CALIFORNIA COASTAL COMMISSION

REVISED FINDINGS

APPEAL NO.: A-6-PSD-09-43

PROJECT DESCRIPTION: Realign North Harbor Drive eastward from the B Street Pier to south of the Broadway Pier. Construct 105 foot wide esplanade; public plaza at the foot of West Broadway; gardens; shade pavilions; ticket kiosks; information building; walk-up café; restroom; median improvements on West Broadway between North Harbor Drive and Pacific Highway; and restripe to provide an additional turn lane to the Grape Street and North Harbor Drive intersection. The project will result in a net reduction of 146 existing public parking spaces.

EXHIBIT NO. 2
APPLICATION NO.
A-6-PSD-09-43
Figure 5.3 of NEVP
Incorp'd by Ref. Into PMP
 California Coastal Commission

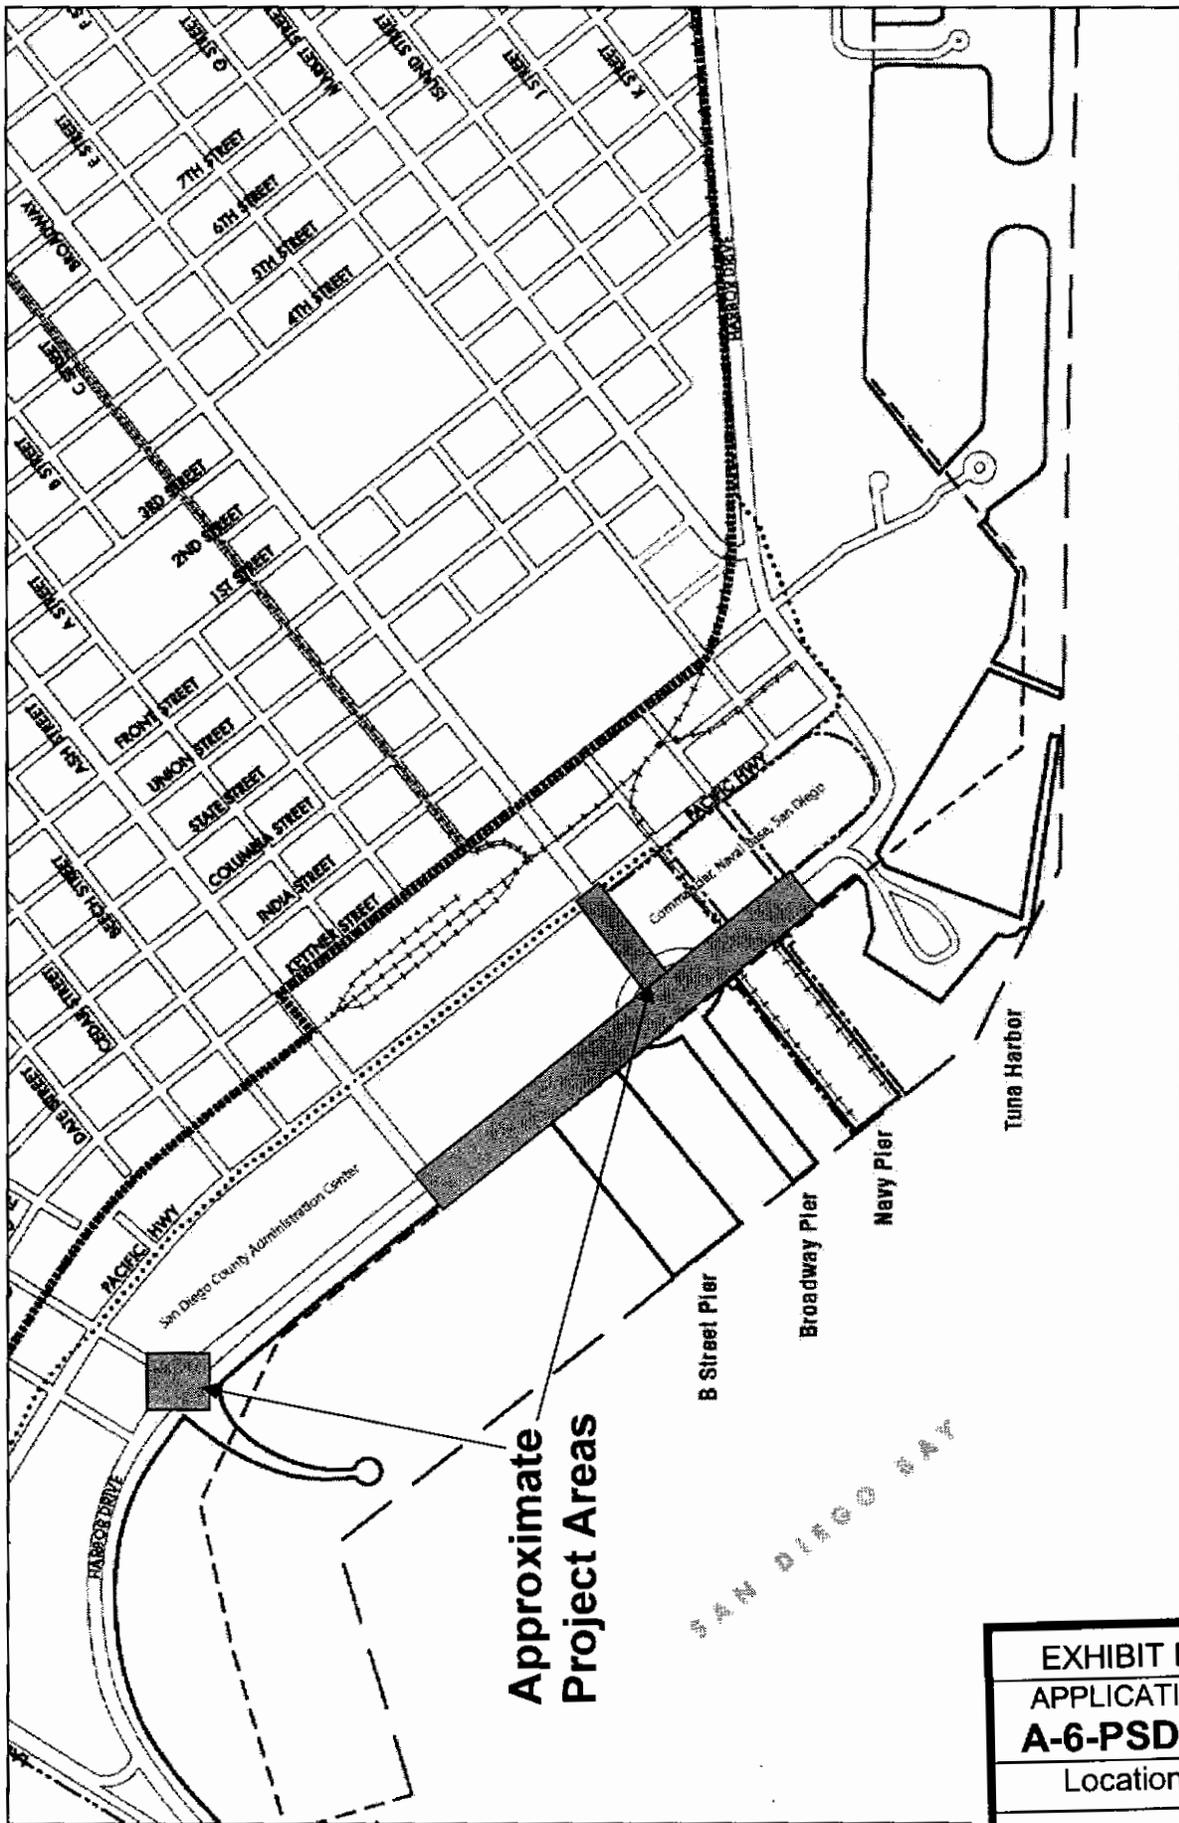
There are other more minor differences between the project and the certified PMP. The proposed project involves construction of a promenade that is different than Figure 5.3 of the NEVP, which is incorporated by reference into the PMP (ref. Exhibit #2 of this staff report for Figure 5.3; compare to Exhibit C in the "Approved Port CDP," attached to Exhibit #4 of this staff report).

Once a policy, figure, or project is inserted into the PMP, it is no longer guidance, but the standard of review. The configuration of the proposed esplanade is different than the one in Figure 5.3. For example, the proposed promenade is 29, not 25 feet wide; instead of a dedicated bike path adjacent to Harbor Drive, there is a new water quality feature, and other small adjustments have been made to the design of the esplanade including changing a 10-foot wide designated bike path to a 29-foot wide multi-use promenade.

As noted above, there are other minor differences between the project and the certified PMP, including revisions to the promenade. Most of these changes are inconsequential improvements to the design of the esplanade. One particular revision which could adversely impact public access is the decision to change the 10-foot wide designated bike path to a 29-foot wide combined bicycle/pedestrian walkway.
